HOWARD COUNTY HEALTH DEPARTMENT

RE: Payne property; 3 lots
Watersville Road area

RE: Payne Tract

PAYNE TRACT

PLAT TO
ACCOMPANY
VARIANCE APPLICATION
VP-77-92

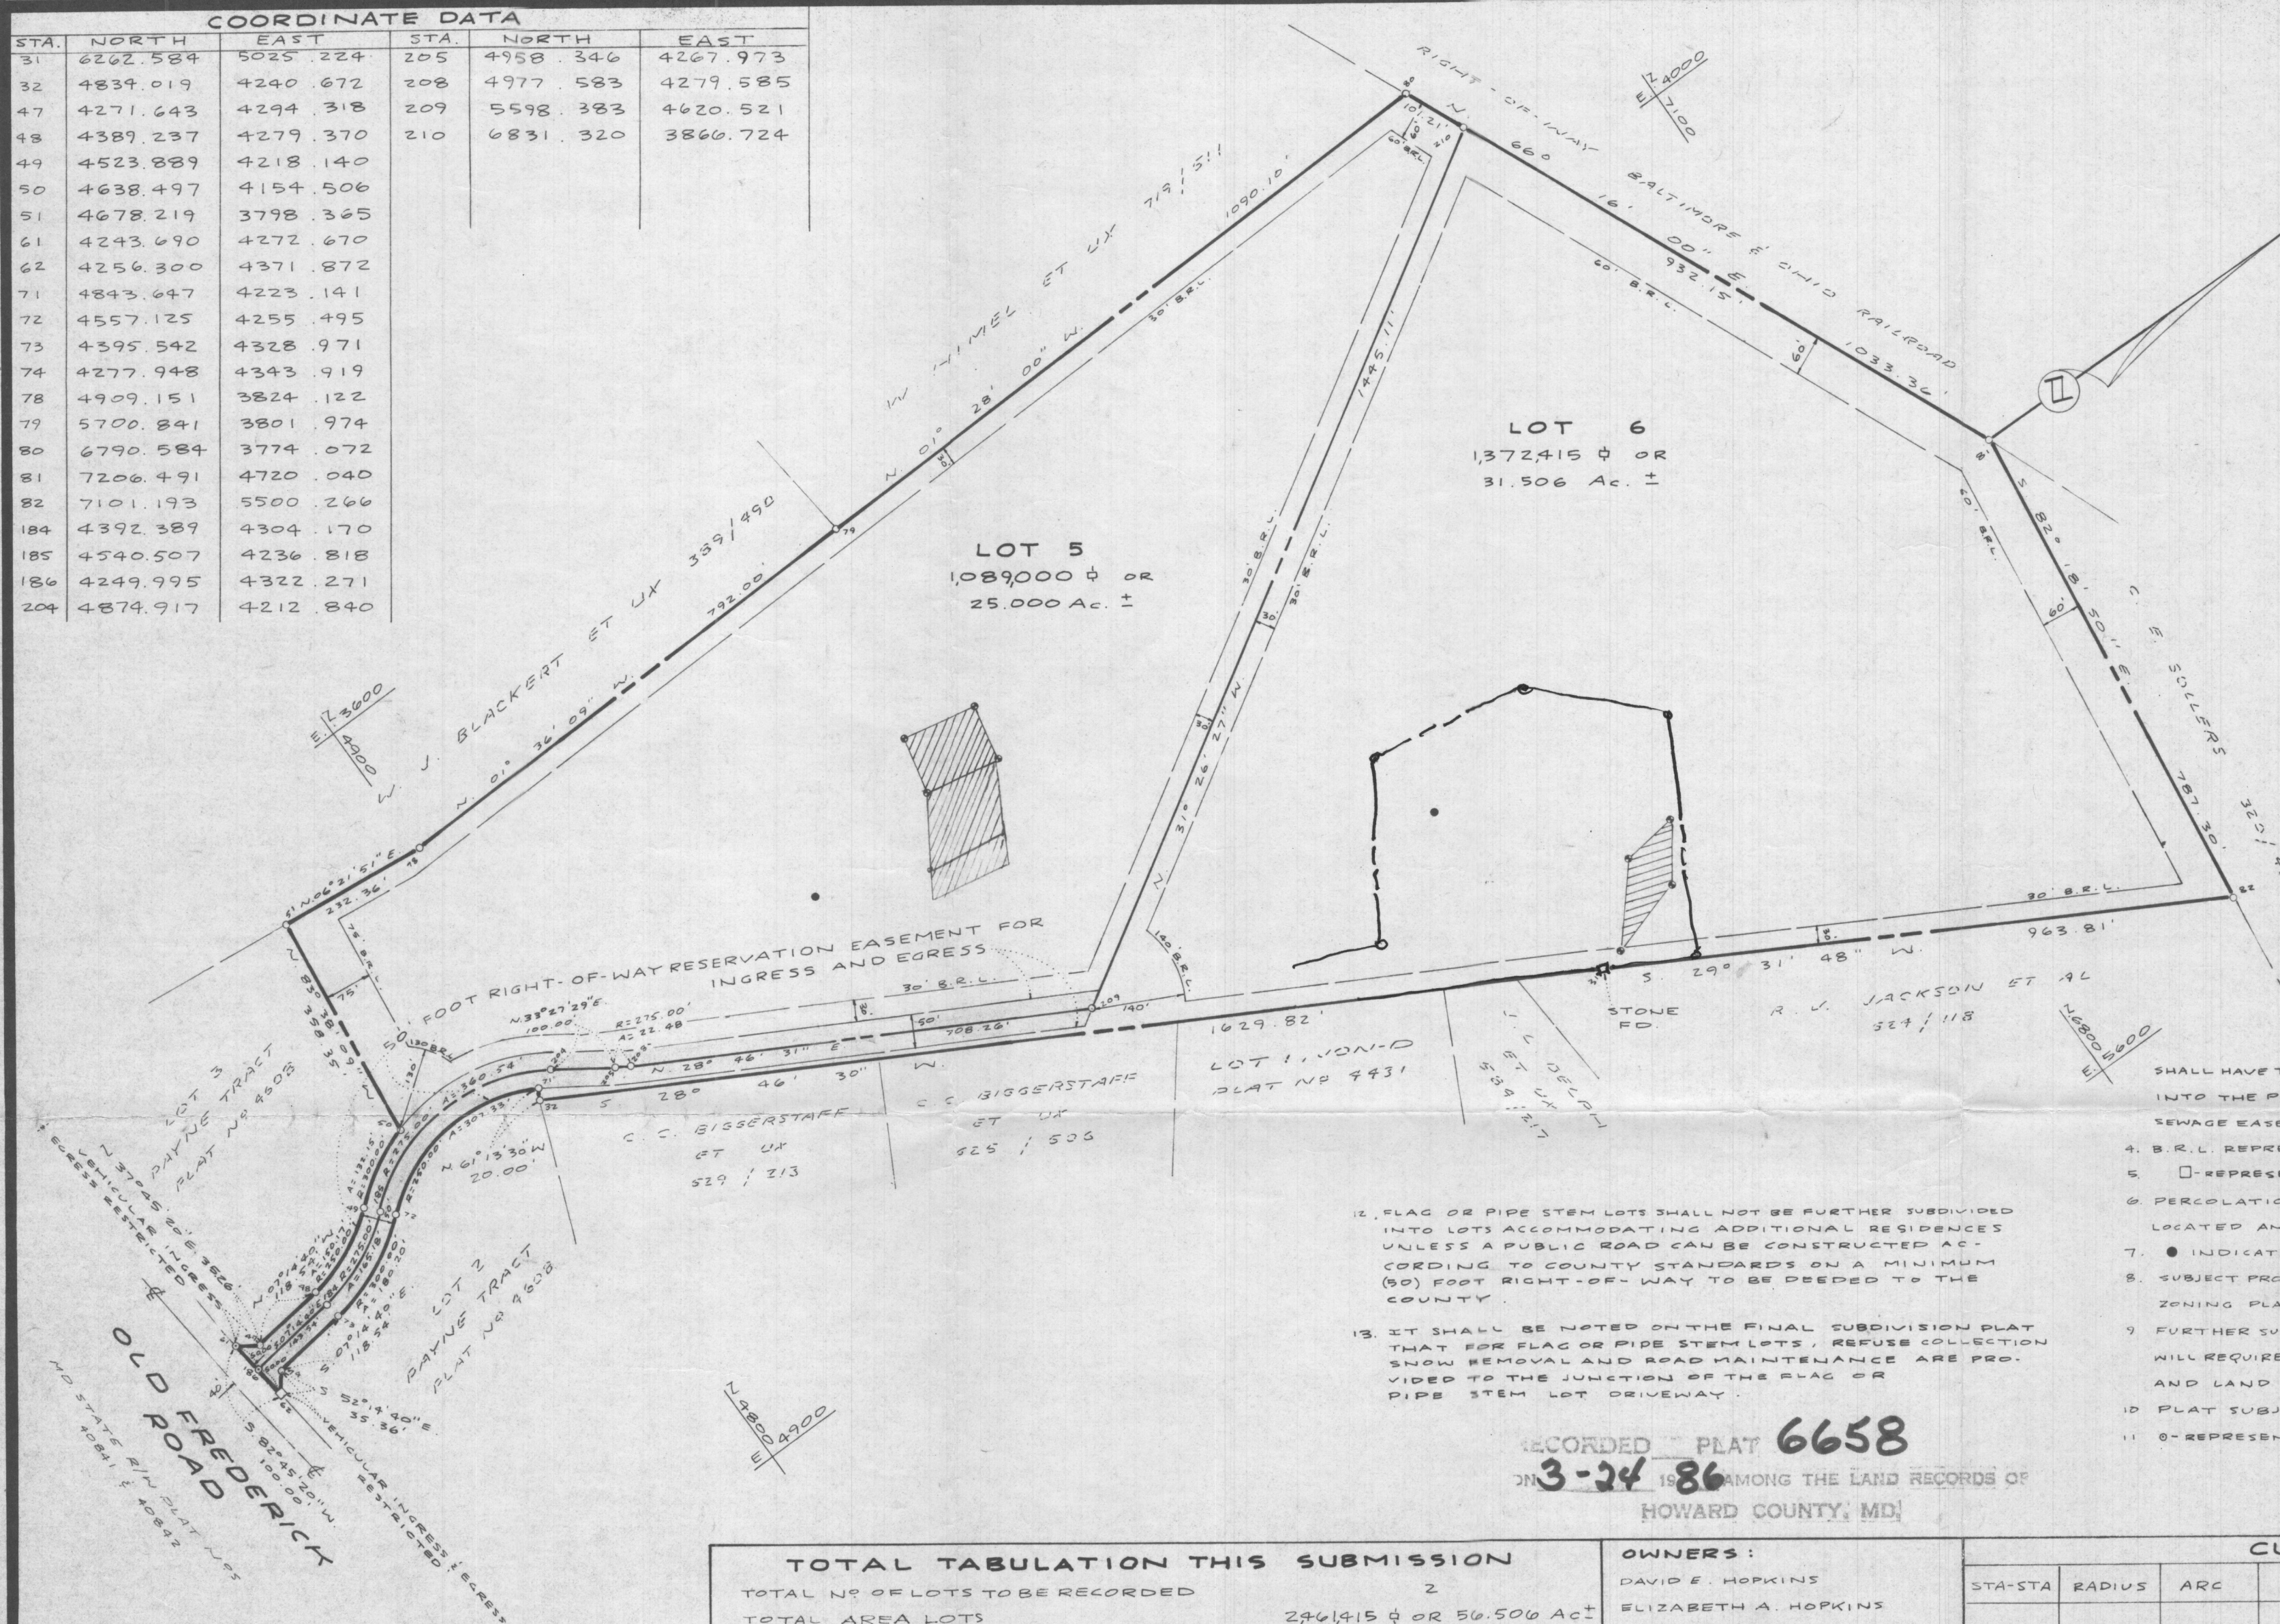
(1) Sewage easement statement
in total.

(2) Minimum ownership
clause needed

(3) Lots #1 + #2 are not approved
all holes are not shown.

(5) J. Stayer agrees his #3 not shown
correctly.

Please be advised that the Health Department, after calling for revisions of percolation areas on present platt, still is awaiting an updated platt with more complete and accurate information.

2/29/80 Write letter. (Need revisions.
C.B.
